City of Portland, Maine – Building or Use Permit Application 389 Congress Street, 04101, Tel: (207) 874-8703, FAX: 874-8716

BUILDING PERMIT REPORT

DATE: 2 OCT. 98 ADDRESS: 52 Belmont St. 126-C-0041
REASON FOR PERMIT: 16x20' Carport
BUILDING OWNER: Trynor
CONTRACTOR: J. C. Bowe
PERMIT APPLICANT: _____
USE GROUP U BOCA 1996 CONSTRUCTION TYPE 5B

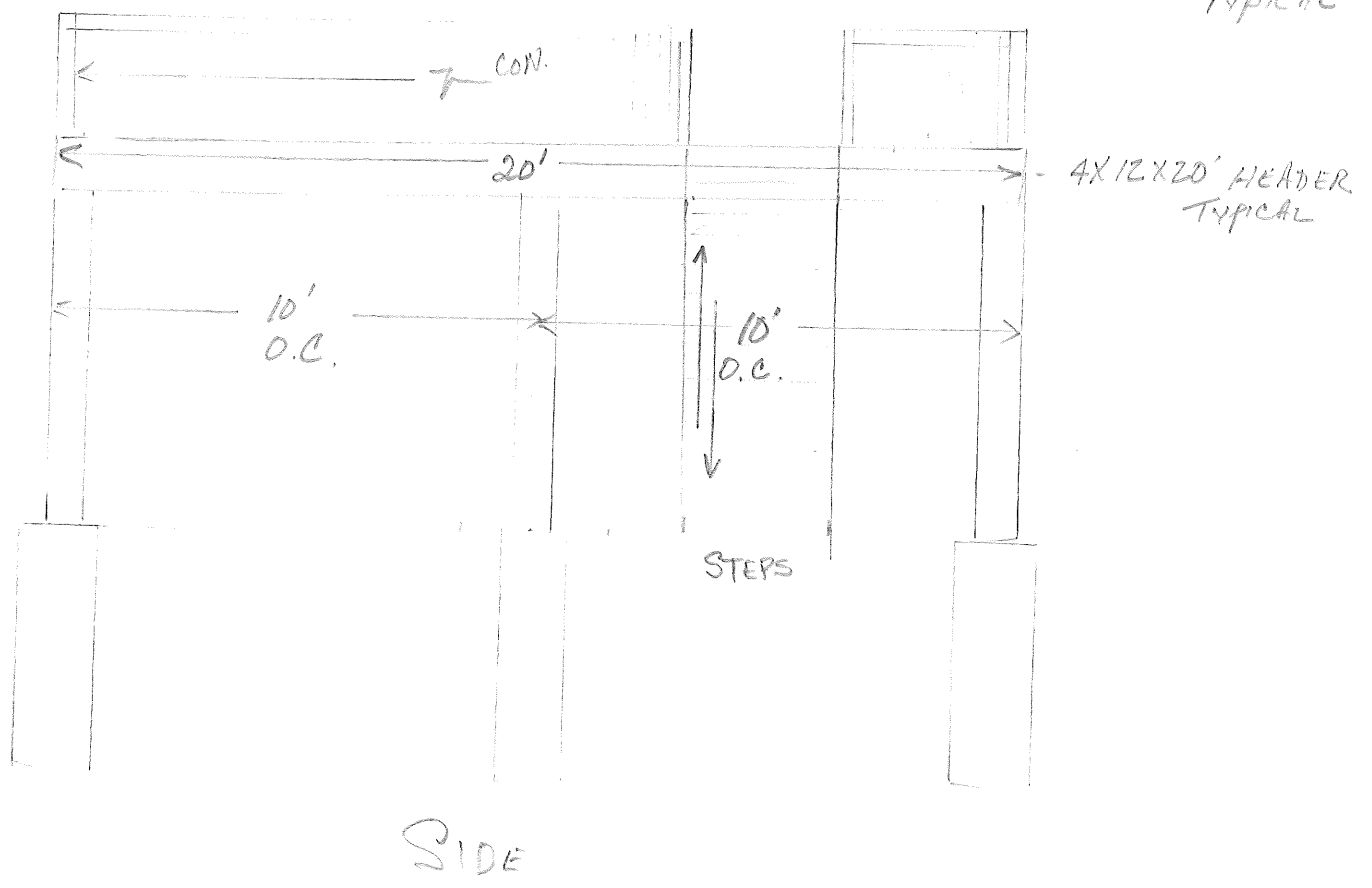
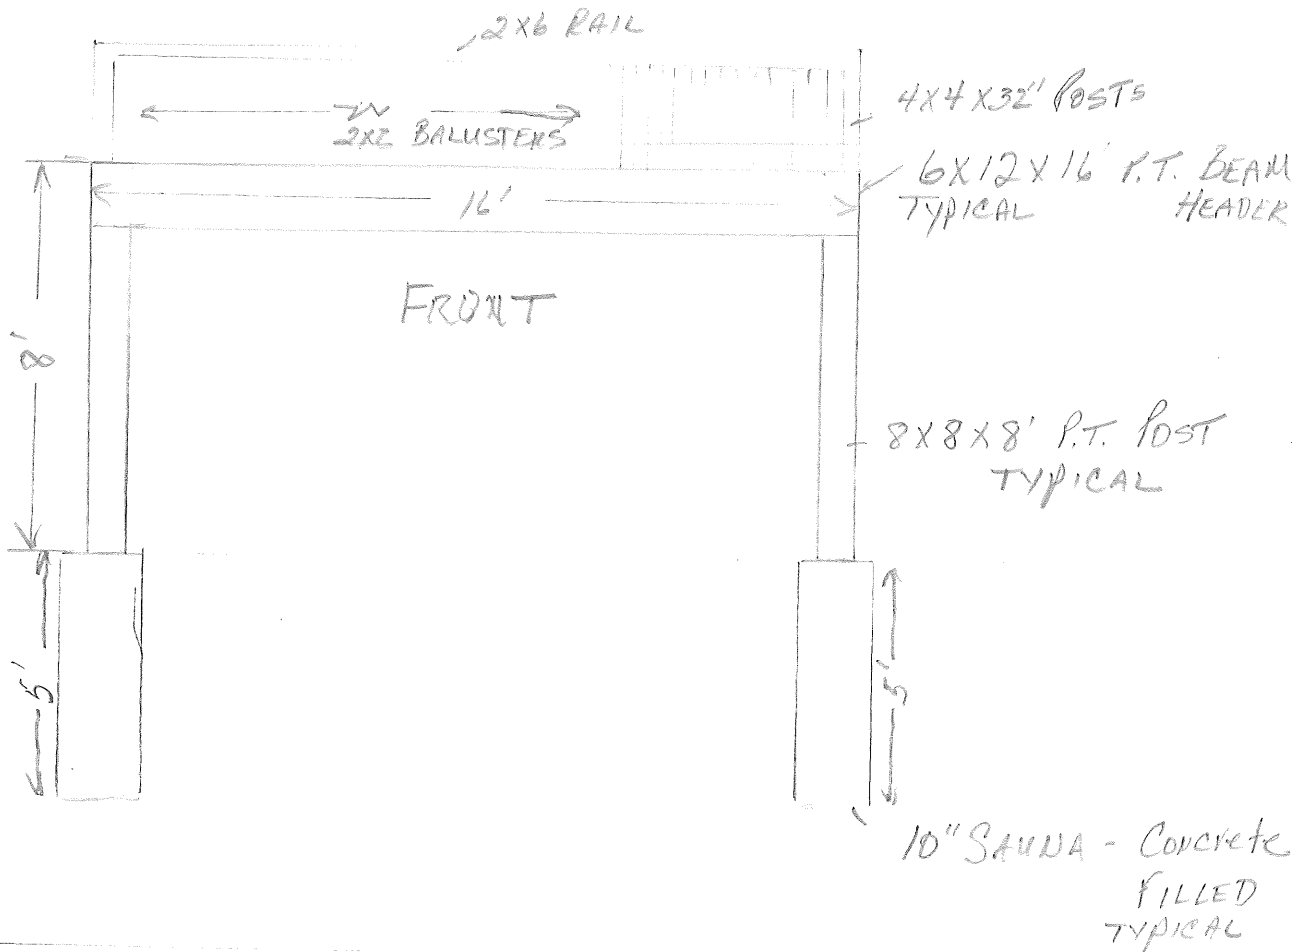
29. The proposed foundation 10" 3000 Tubes must rest on footings with anchors or on bedrock - Also the foundation must have fasteners between piers and wood structural members.

30. The 8'x8'x8' Post must be braced, To prevent movement.
